SUBJECT: NORTH ANNA POWER STATION, UNIT NOS. 1 AND 2 – ISSUANCE OF  
AMENDMENT NOS. 282 AND 265 TO REVISE TECHNICAL SPECIFICATIONS  
REGARDING OPEN PHASE PROTECTION (EPID L-2018-LLA-0132)

SAFETY EVALUATION BY THE OFFICE OF NUCLEAR REACTOR REGULATION

NORTH ANNA POWER STATION, UNIT NOS. 1 AND 2

Figure 1: Figure 14.1 of the NEMA-MG1

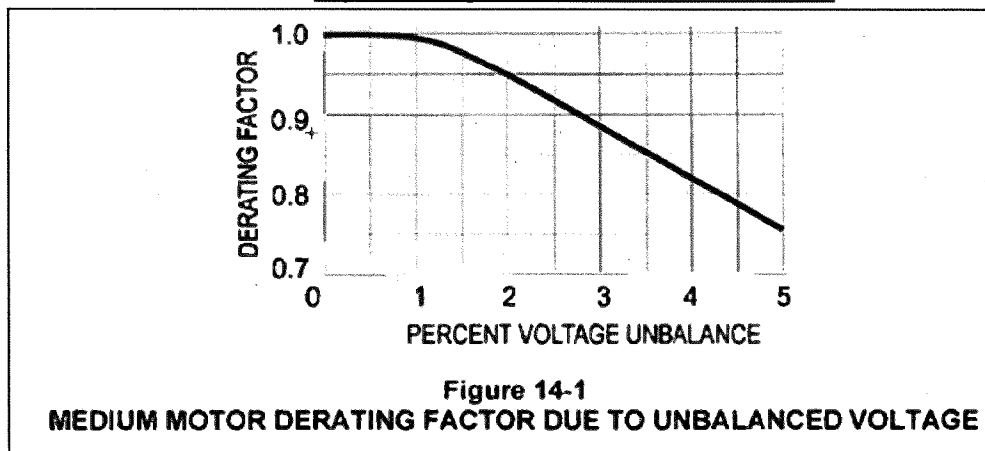
In the Figure 14.1, "Medium Motor Derating Factor Due to Unbalance Voltage," of NEMA-MG1, the derating curve shows when voltages are unbalanced, the rated horsepower of the motor should be multiplied by the factor to reduce the possibility of damage to the motor, as shown in Figure 1 below:

NEMA MG-1 states, in part, "Operation of the motor above a 5-percent unbalance voltage condition is not recommended."

Figure 2: NRC Staff Margin Calculation

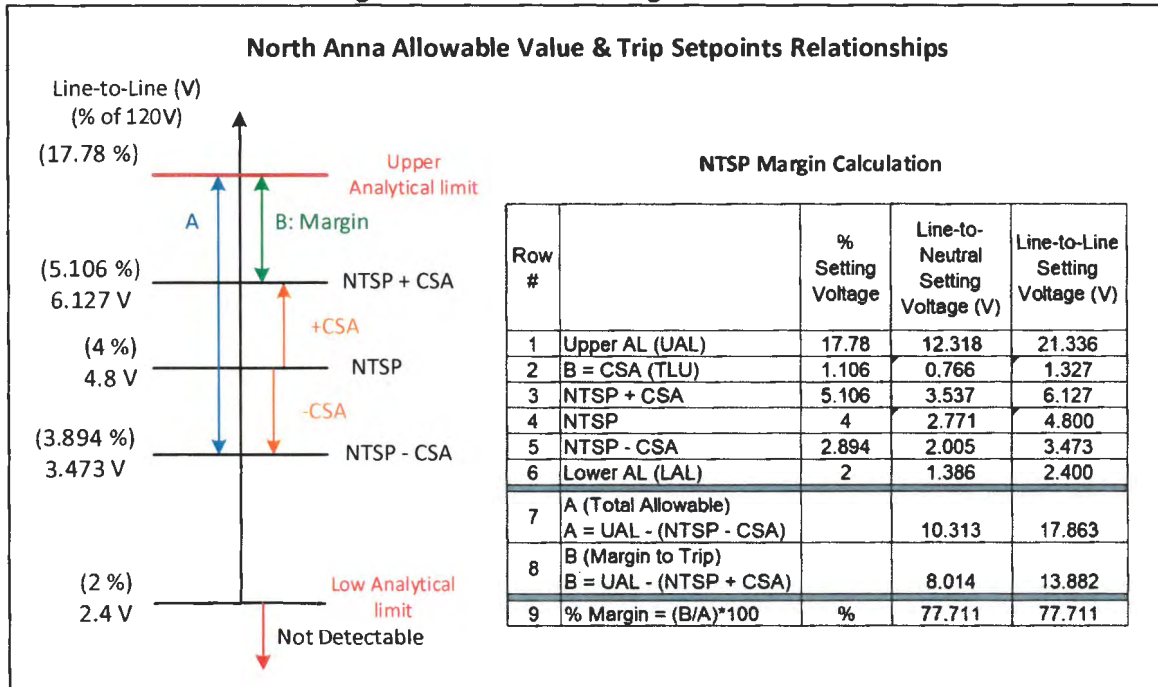
The NRC staff calculated independently the margin between AL and NTSP. The NRC calculation results are reflected in the Negative Sequence Voltage Figure 2 below.

Therefore, the NRC staff determined from its independent calculation of the Margin to Trip between AL and NTSP that there is significant margin (as indicated in the Figure 2 above) at a value of 77.71 %. This margin reflects that the trip setpoints have been chosen to assure that a trip or safety actuation will occur automatically before the measured process reaches the Upper Analytical Limit (UAL) level.

Figure 3: Figure 4 of the BE1-47N Instruction

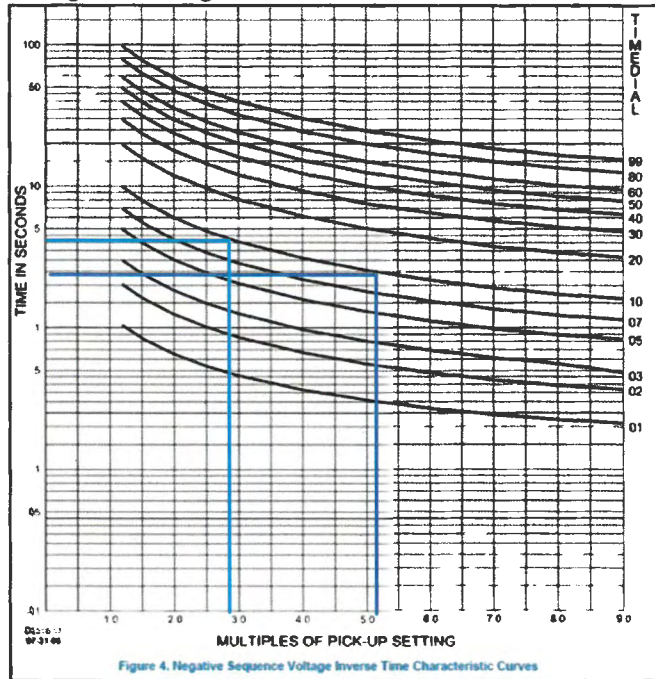
The NRC staff reviewed Figure 4, "Negative Sequence Voltage Inverse Time Characteristic Curves," of the instruction of the BE1-47N to verify that the time in seconds of the time dial setting of "10" has a maximum at 10 seconds, at a minimum of multiples of pick-up setting of  $(1.2\% \times 120 = 1.44\text{V L-L})$ . This diagram (see Figure 3 below) shows that the pick-up setting is inverse with respect to the time (in seconds). Therefore, the licensee's proposed 4% relay pickup setting with a time dial setting of 10 accounts for both positive and negative CSA uncertainty ( $\geq 2.894\%$  and  $\leq 5.106\%$  of span). This range spans from approximately  $\geq 3.3$

seconds to  $\leq 4.7$  seconds.

This time delay setting ensures that the actuation will occur in less than 10 seconds.

The NRC staff finds the proposed time delay setting within the range of approximately  $\geq 3.3$  seconds and  $\leq 4.7$  seconds (as shown in Figure 3 of this SE) for the proposed UVRs time delay setting for North Anna Units 1 and 2 provides reasonable assurance that a trip or safety actuation will occur within the allowable time to protect safety related equipment. Hence, an automatic protective action will correct the abnormal situation before a safety limit is exceeded. Therefore, the NRC staff determines that this time delay setting satisfies the requirements of 10 CFR 50.36(c)(1)(ii)(A) and is, therefore, acceptable.
